Title of PCN:			
Correction of datasheet for SSD some parts			
Customer PCN No.		Supplier PCN No.	PCN17006
Please check the appropriate box below:

Comparison report

Prepared by Riona
Checked by Celia
Approved by Celia
Issued date at Dec.28.2016
Reversion for A

Comparison report

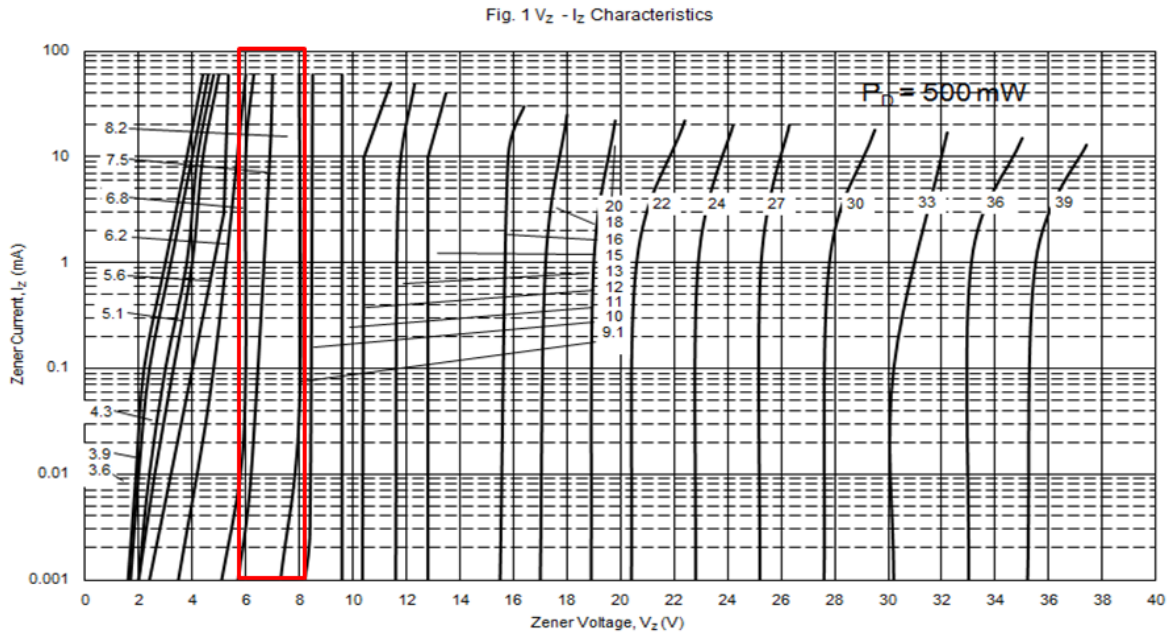
Before	After	Result																									
Correction Datasheet	RB751V-40 No marking code old datasheet version MECHANICAL DATA Case : SOD-323 small outline plastic package Terminals : Matte tin plated, lead free, solderable per MIL-STD-202, method 208 guaranteed High temperature soldering guaranteed : 260°C/10s Polarity : Indicated by cathode band Weight : 0.004grams (approximately)	RB751V-40 Add marking code: 5 new datasheet version MECHANICAL DATA Case : SOD-323 small outline plastic package Terminals : Matte tin plated, lead free, solderable per MIL-STD-202, method 208 guaranteed High temperature soldering guaranteed : 260°C/10s Polarity : Indicated by cathode band Weight : 0.004grams (approximately) Marking code 5	product no change																									
	MTZJ2V0SA ~ MTZJ56S Series VZ-IZ graph no 8.2 curve	MTZJ2V0SA ~ MTZJ56S Series VZ-IZ graph add 8.2 curve	product no change

Subject: MTZJ2V0SA ~ MTZJ56S Series

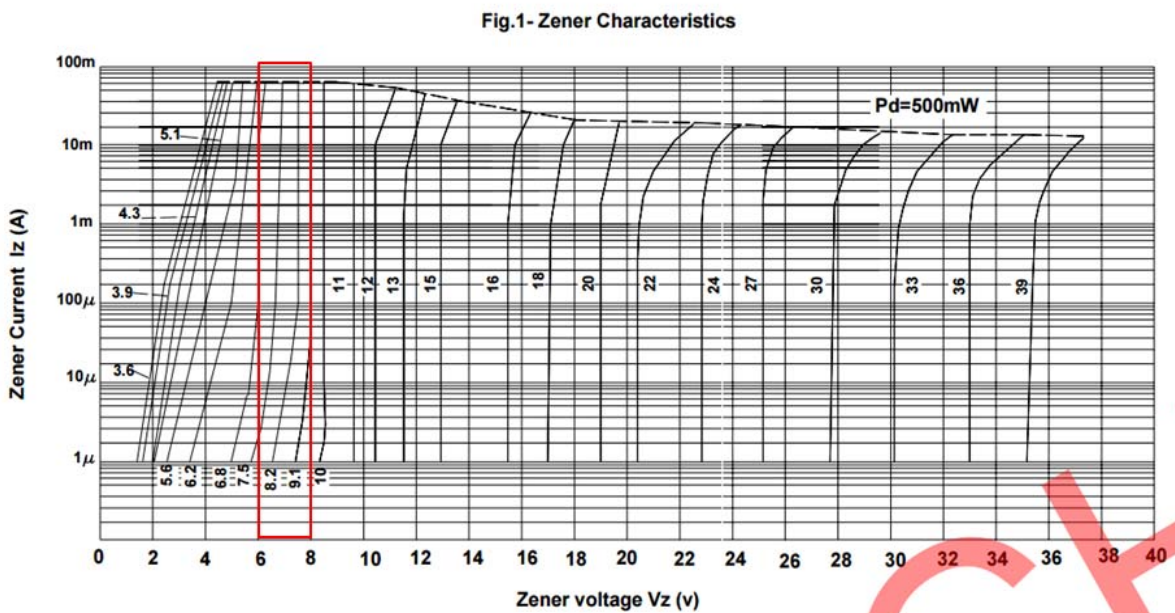
TS4148 RWG no marking diagram	TS4148 RWG add marking diagram 	product no change																									
	MTZJ9V1SC Marking Code : 9V2C <table border="1" style="display: inline-table; border-collapse: collapse; text-align: center;"> <tr><td rowspan="3" style="padding: 2px;">MTZJ9V1S</td><td style="padding: 2px;">A</td><td style="padding: 2px;">9V1A</td><td style="padding: 2px;">8.29</td><td style="padding: 2px;">8.73</td></tr> <tr><td style="padding: 2px;">B</td><td style="padding: 2px;">9V1B</td><td style="padding: 2px;">8.57</td><td style="padding: 2px;">9.01</td></tr> <tr><td style="padding: 2px;">C</td><td style="padding: 2px; border: 1px solid red;">9V2C</td><td style="padding: 2px;">8.83</td><td style="padding: 2px;">9.30</td></tr> </table>	MTZJ9V1S	A	9V1A	8.29	8.73	B	9V1B	8.57	9.01	C	9V2C	8.83	9.30	MTZJ9V1SC Marking Code : 9V1C <table border="1" style="display: inline-table; border-collapse: collapse; text-align: center;"> <tr><td rowspan="3" style="padding: 2px;">MTZJ9V1S</td><td style="padding: 2px;">A</td><td style="padding: 2px;">9V1A</td><td style="padding: 2px;">8.29</td><td style="padding: 2px;">8.73</td></tr> <tr><td style="padding: 2px;">B</td><td style="padding: 2px; border: 1px solid red;">9V1B</td><td style="padding: 2px;">8.57</td><td style="padding: 2px;">9.01</td></tr> <tr><td style="padding: 2px;">C</td><td style="padding: 2px; border: 1px solid red;">9V1C</td><td style="padding: 2px;">8.83</td><td style="padding: 2px;">9.30</td></tr> </table>	MTZJ9V1S	A	9V1A	8.29	8.73	B	9V1B	8.57	9.01	C	9V1C	8.83	9.30

old datasheet version

new datasheet version
